Summary of Items Discussed in 4/2022 APSEC Discussion Forum on 12 August 2022

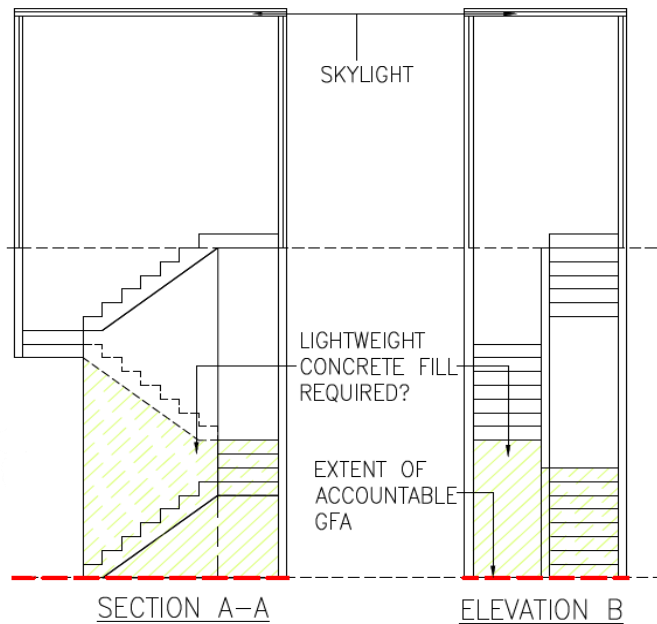
3.	<p><u>Height of Storeys</u></p> <p>According to paragraph 5 of PNAP APP-5, for the purpose of regulation 23(3)(a) of the Building (Planning) Regulations (B(P)R), the maximum acceptable storey height of a domestic flat at the topmost floor is 4 m.</p> <p>We would like to seek BD’s advice if the storey height of the common area outside the residential flat exceeding 4 m is acceptable for technical reasons to cater for waterproofing construction and 150 mm level differences between indoor at outdoor at main roof level.</p>	<p>BD advised that provided that the storey height of the flat at topmost floor did not exceed 4 m as well as the common area outside was of genuine design and its abuse was unlikely, the BA would favourably consider accepting the common corridor with high storey height on a case-by-case basis.</p>

6. **Projections from External Wall – PNAP APP-19**

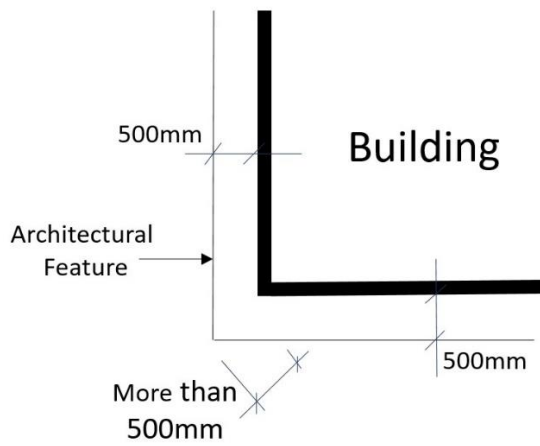
Paragraph 3(f) of PNAP APP-19 states that architectural mouldings and the like features complying with the projection (i.e. project no more than 500 mm over a street) and clear height limits in regulation 7(1) of the

<p>B(P)R need not be counted for site coverage (SC) and plot ratio (PR). Where such feature is located around the external wall corner of a building as per the following sketch plan, it is inevitable that the feature at the corner will be more than 500 mm as measured diagonally from the wall corner. Similarly, for wall signboard projecting not more than 600 mm from the external wall and located around the external wall corner, the signboard will also be slightly more than 600 mm when measured diagonally from the wall corner. We understand that BD will give favourable consideration to the above arrangement. Please advise if our understanding is correct.</p> 	<p>made to item 12 of ADF 5/2012 held on 26 October 2012, in which similar consideration was applied to curtain wall situation.</p>
<p>7. <u>Fire Resistance Rating (FRR) for an Enclosed Footbridge over a Public Street between Two Buildings – Clause C15.1 of the FS Code</u></p> <p>An enclosed footbridge is proposed to be constructed as part of Building I over a public street to connect Building II on the other side of the street. We understand that:</p>	<p>BD advised that with regard to the situation illustrated in the sketch that the buildings are situated on two different sites separated by a public street and an enclosed footbridge is proposed to be constructed as part of</p>

For the purpose of PNAP APP-19, BD accepted that part of the architectural feature wrapping around the corner of a building as shown in the sketch plan need not be counted for SC and PR. Reference was

8. **Definition of Underground Car Park – Paragraph 3(a) of Appendix C to PNAP APP-2**

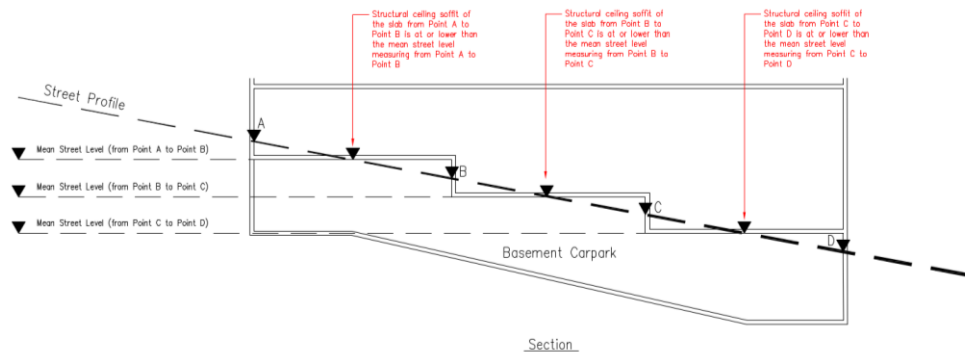
If the site is abutting a sloping street, and the structural ceiling slab of the underground car park is stepping down with varying levels to align with the sloping street, would BD consider to accept the car park as a underground car park if the all levels of the structural ceiling slabs are either (i) at or below the mean street level or (ii) at or below the mean level of that portion of the street, as shown in the diagram below.

Regarding to the definition of an underground car park, BD advised that for car park abutting a sloping street, according to paragraph 3(a) of Appendix C to PNAP APP-2, BD might consider accepting a car park as an underground one if the structural ceiling soffit of the car park was at or below the mean level of that portion of the street on which the site abutted. In general, there should only be a single mean level for the entire portion of the street which the site abutted.

The information provided by HKIA was not sufficient for BD to consider the case. HKIA would provide further information about the case for discussion with BD separately.

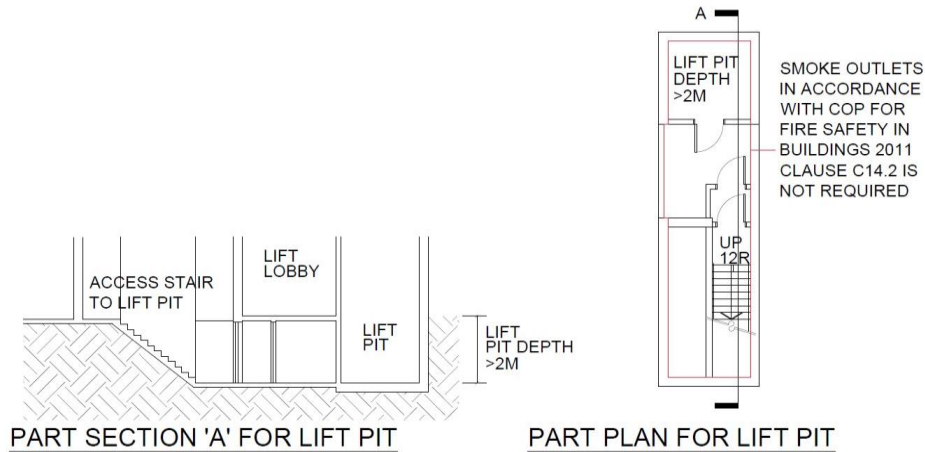
To our understanding, provision of smoke outlets in accordance with Clause C14.2 of the FS Code for the abovementioned lift pit and the associated maintenance and access area is not required. A typical case is demonstrated in below diagrams.

Please advise if our understanding is correct.

15. **Space Underneath Internal Staircase**

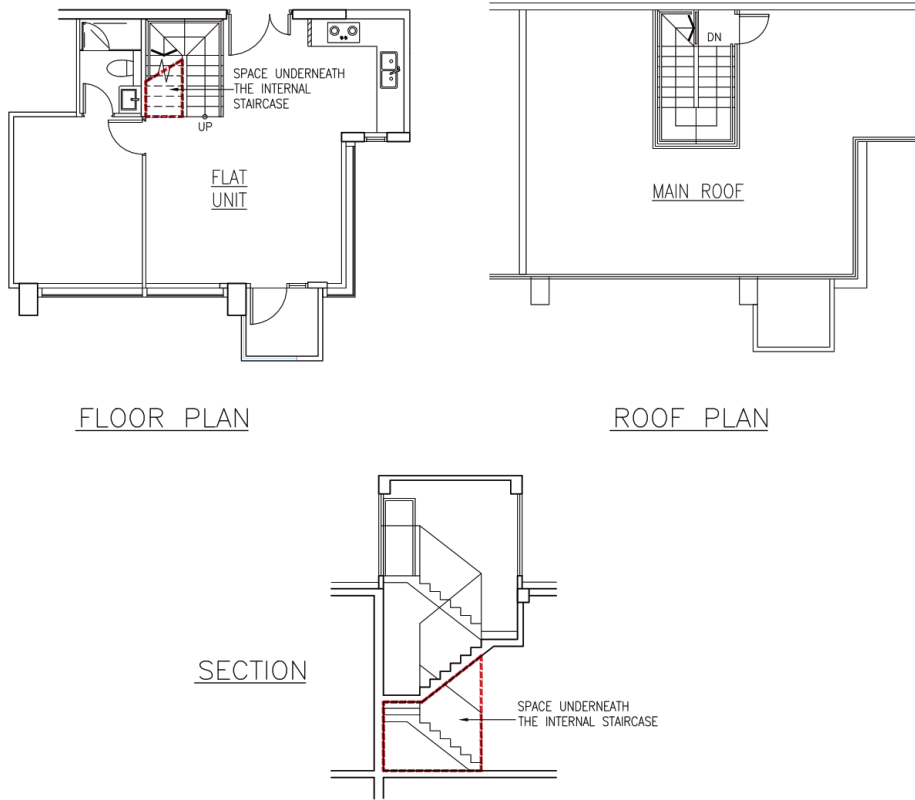
Space underneath an internal staircase within a staircase core which leads to the main roof of a building is accountable for GFA calculation.

Based on the above, we opine that the underside of the staircase need not be filled up by light-weight mass concrete to avoid abusive use of the subject space. Please advise whether our interpretation is correct.

BD advised that AAP's understanding was correct.

16. **Location of Open Kitchen**

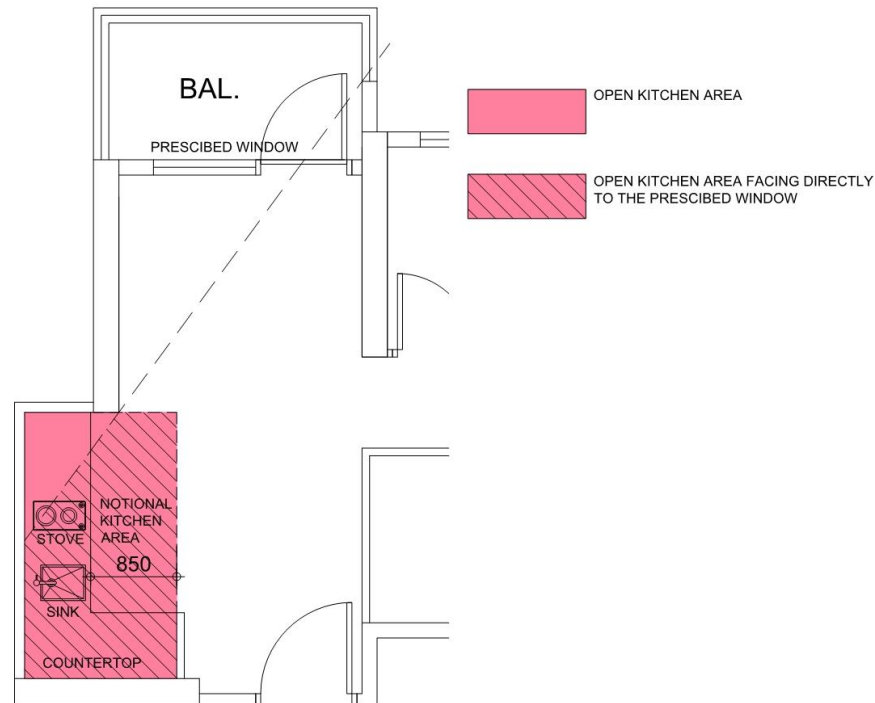
We would like to seek BD's clarification if our following understanding is correct as illustrated in the attached sketch:

More than 50% of the kitchen area (including 850 mm deep notional kitchen area) facing directly to the prescribed window will be deemed to comply with the aforementioned requirement on natural lighting and ventilation.

BD advised that as per item 22 of ADF 2/2021 held on 19 March 2021, open kitchen should be located in a position where most of the open kitchen area could face the concerned prescribed window(s) of the room for the required natural lighting and ventilation. To this end, the open kitchen in the sketch was considered acceptable.
